IMPROVEMENT PERMIT for a RESIDENTIAL ON-SITE WASTEWATER TREATMENT & DISPOSAL SYSTEM

Residential Subsurface Wastewater Treatment and Disposal System Design

Lot 4 – Stonebridge at Mint Hill
8143 Castlestone Drive
Mint Hill, North Carolina

GWS Septic System Design Review

Sketch of Soil Evaluation Locations

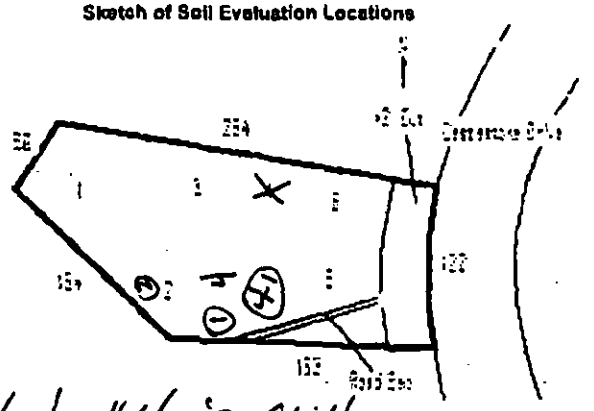
COMMENTS:
Meck County's #4 boring is located at lowest proposed drain line – added two more borings to verify soils.

* Flagging tape for hole #4 is still up - incorrectly noted on sketch.
